**MONTGOMERY COUNTY HISTORIC PRESERVATION COMMISSION**  
**STAFF REPORT**

<b>Address:</b>	13 Grafton Street, Chevy Chase	<b>Meeting Date:</b>	10/14/2020
<b>Resource:</b>	Contributing Resource <b>Chevy Chase Village Historic District</b>	<b>Report Date:</b>	10/7/2020
<b>Applicant:</b>	Norah & Diogo Coelho (Doug Mader, Architect)	<b>Public Notice:</b>	9/30/2020
<b>Review:</b>	HAWP	<b>Staff:</b>	Dan Bruechert
<b>Case Number:</b>	35/13-20DD	<b>Tax Credit:</b>	n/a
<b>PROPOSAL:</b>	Porch Alterations, Building Addition, Hardscape alterations including new curb cut and parking pad.

**STAFF RECOMMENDATION**

OFFICE PORCH - PLAN & ELEVATIONS  
DETAILS & MATERIALS

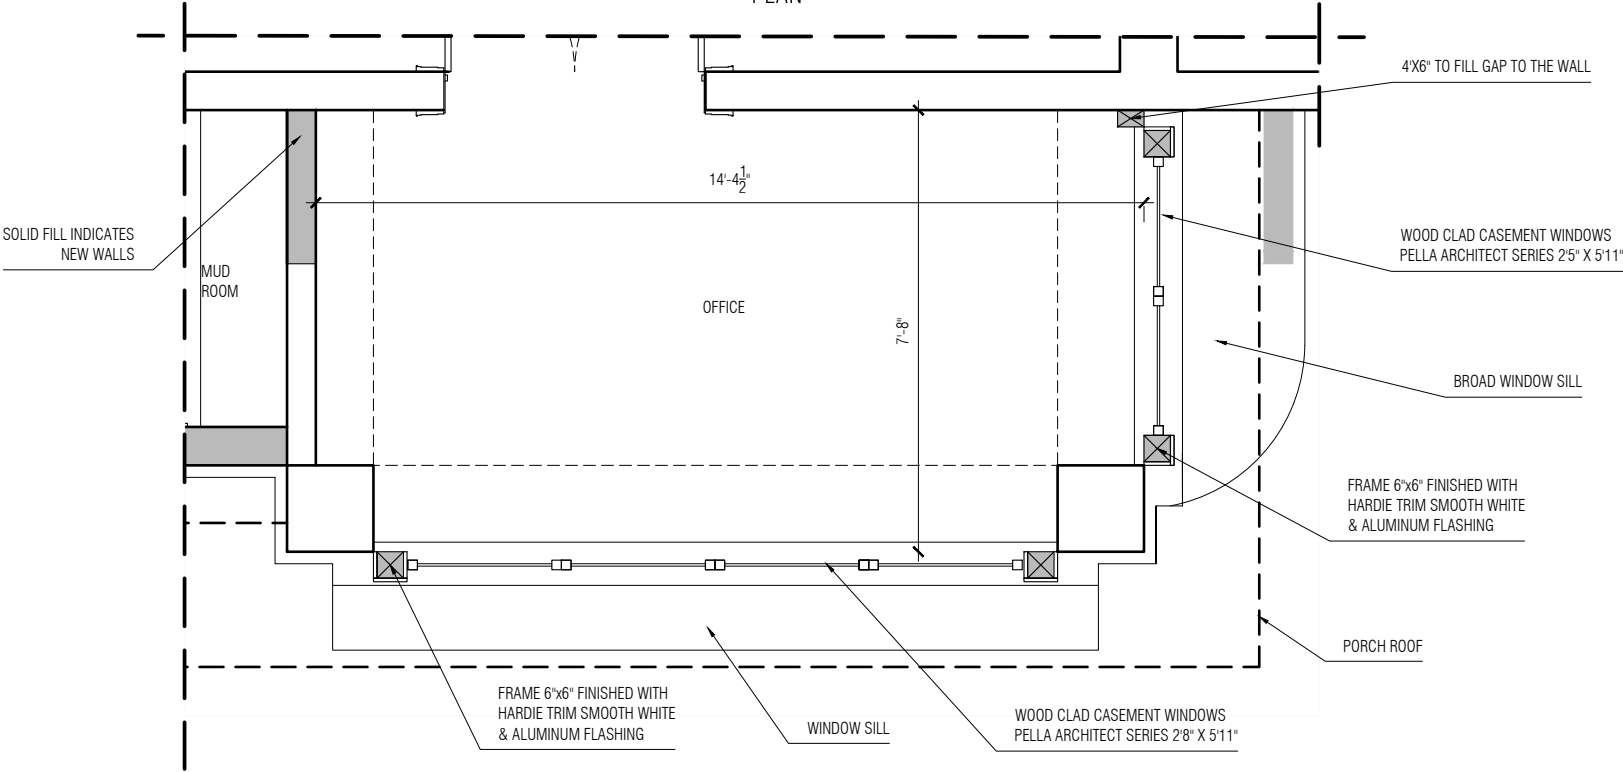
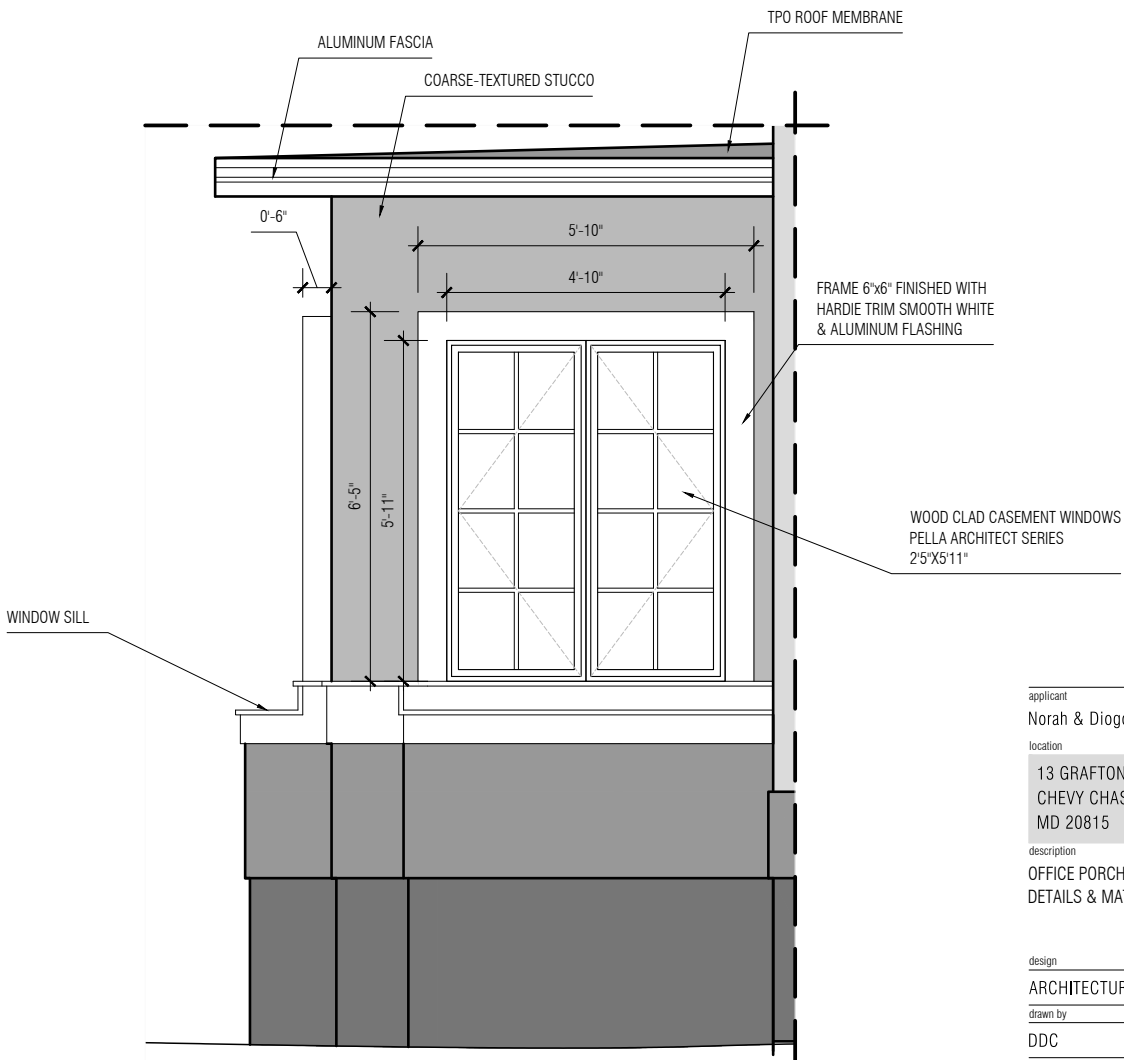
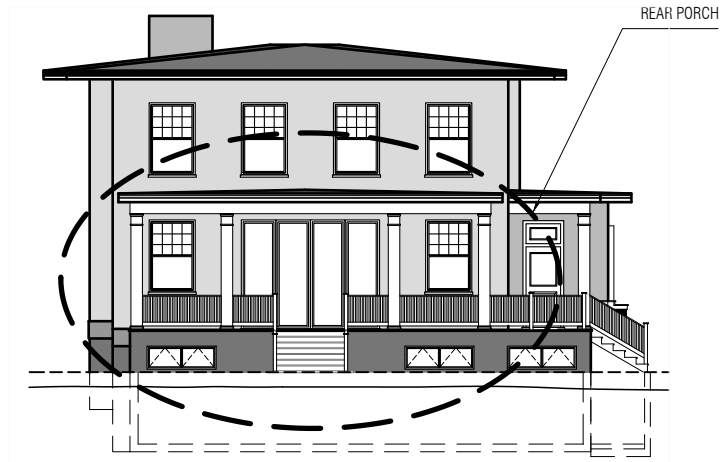
The applicant proposes to enclose the side porch with multi-lite casement windows. The *Design Guidelines* state that side porches have been successfully enclosed and are approvable if compatibly designed. No other alterations are proposed for the side porch. The HPC voiced their support for enclosing the side porch. Staff finds that the porch enclosure is compatible with the character of the house and its approval is supported under the *Design Guidelines*.

applicant  
Norah & Diogo Coelho  
location  
13 GRAFTON ST  
CHEVY CHASE  
MD 20815  
description  
REAR PORCH  
DETAILS & MATERIALS

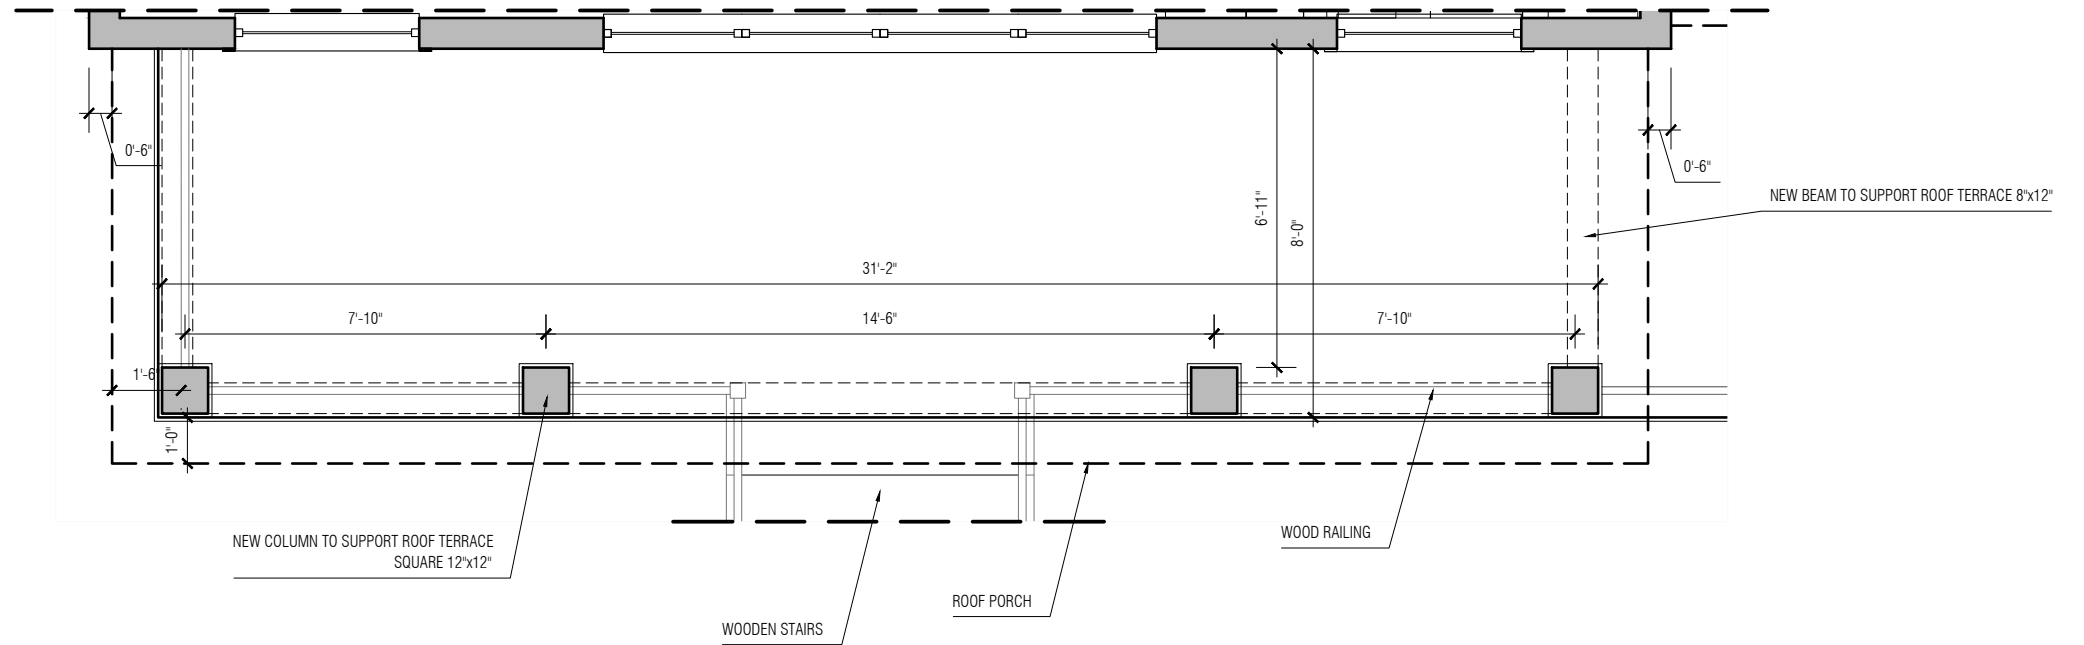
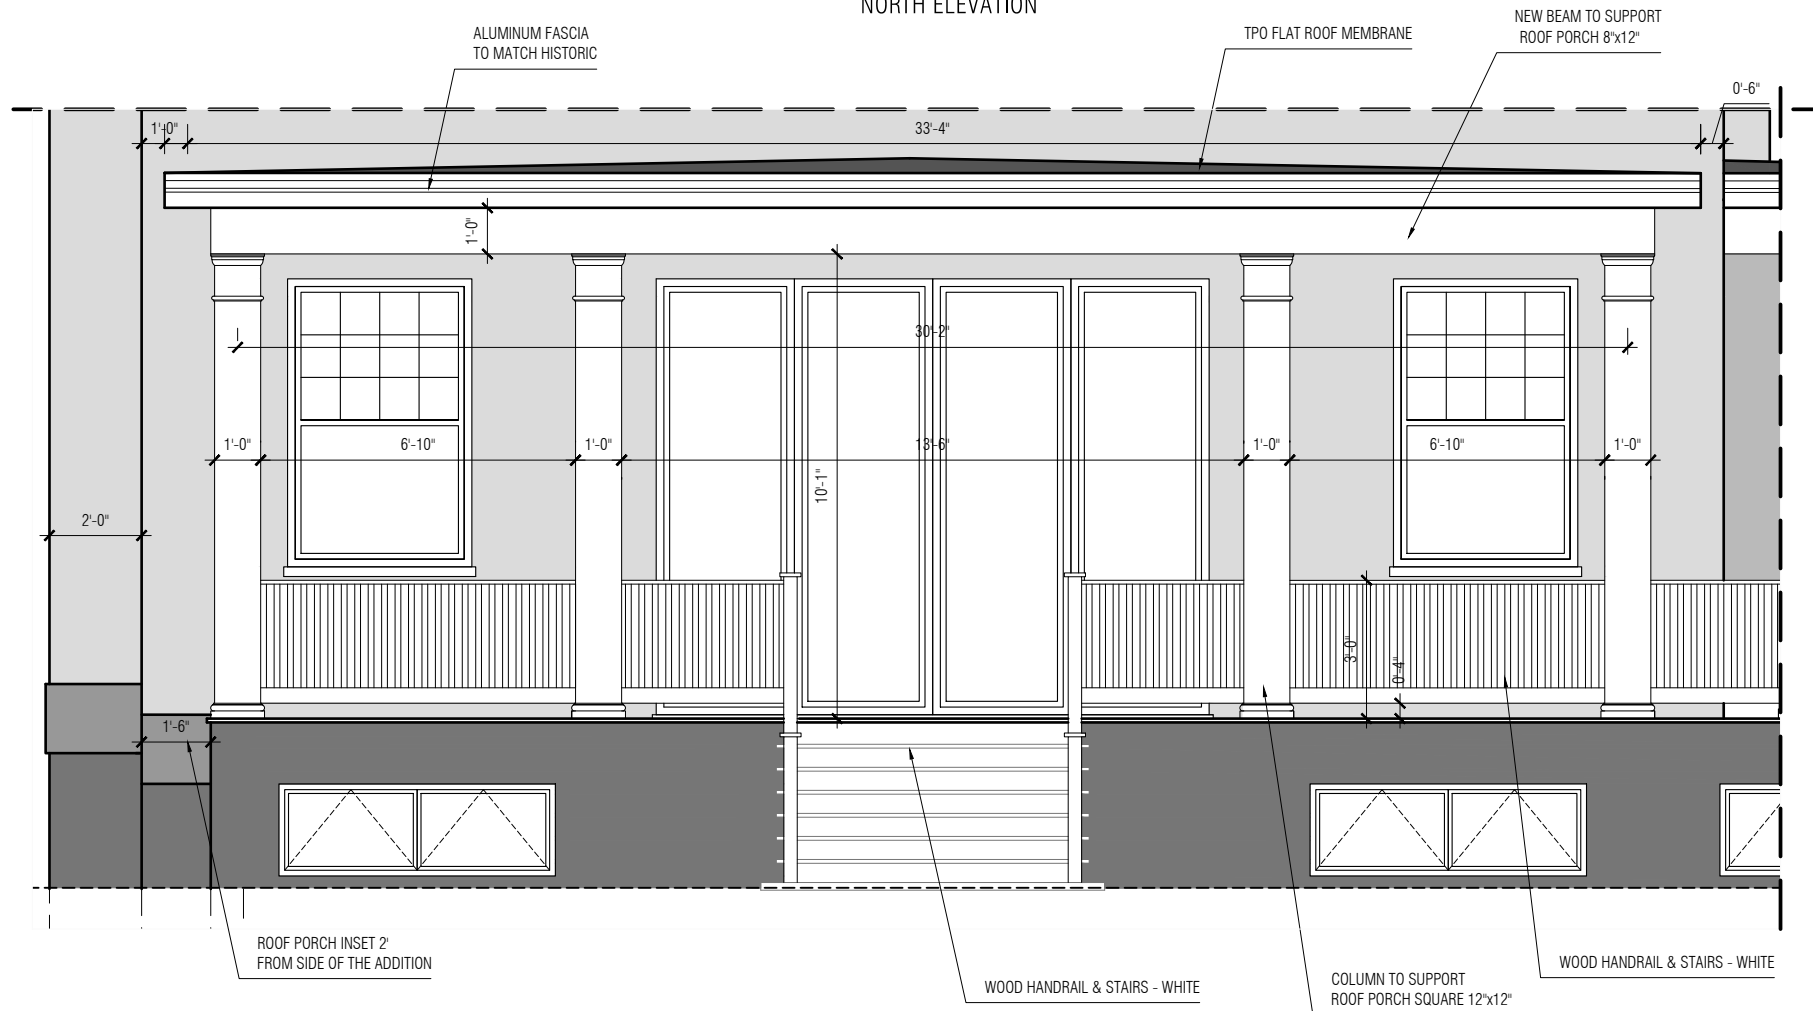
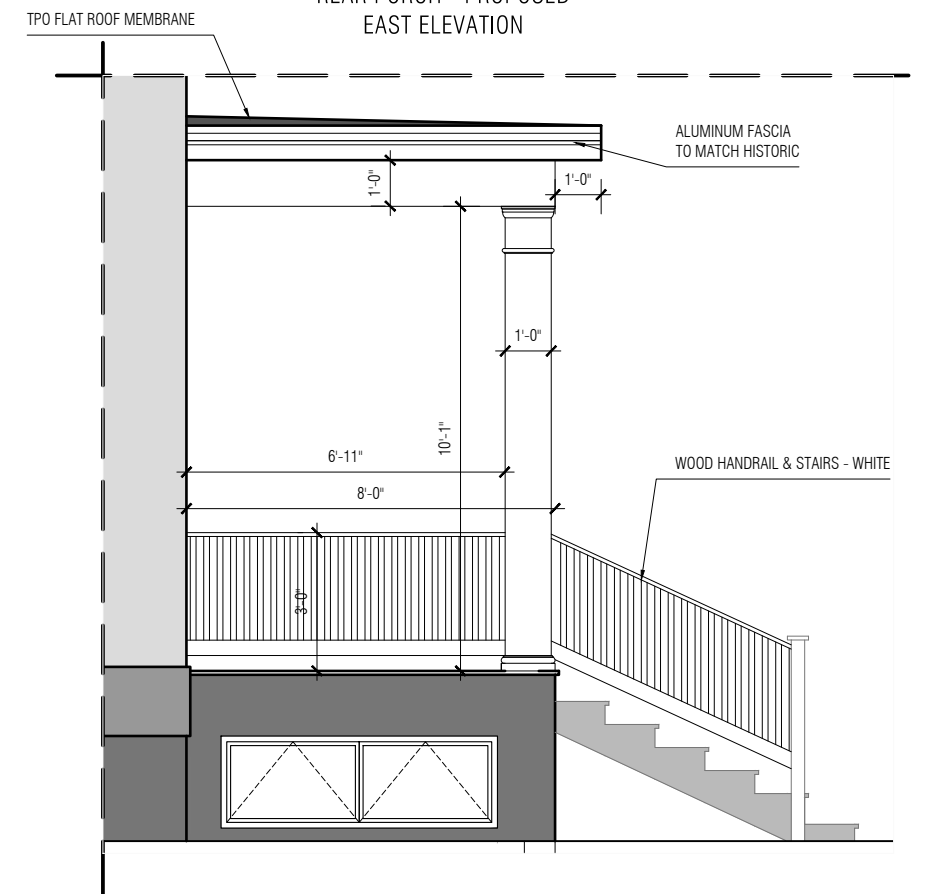
At the rear of the house, the applicant proposes to install a wrap-around porch. The porch at the rear wall will have a flat roof and will be supported by Duracraft Composite square columns with a wood railing and stairs. The northwest corner of the porch will not have a roof but will continue the wood railing. The entrance to the mudroom on the west elevation will have a small roof, matching the detail at the rear.

Staff finds this porch is compatible with the design of the house and will not detract from its character or historical features. It is possible that the northwest corner of the entrance to the mudroom will be visible from the public right-of-way, but will otherwise not be visible. The *Design Guidelines* state that porches not visible from the right of way should be reviewed under moderate scrutiny. Staff finds under this standard, the porch is compatible with the house and surrounding district and should be approved.
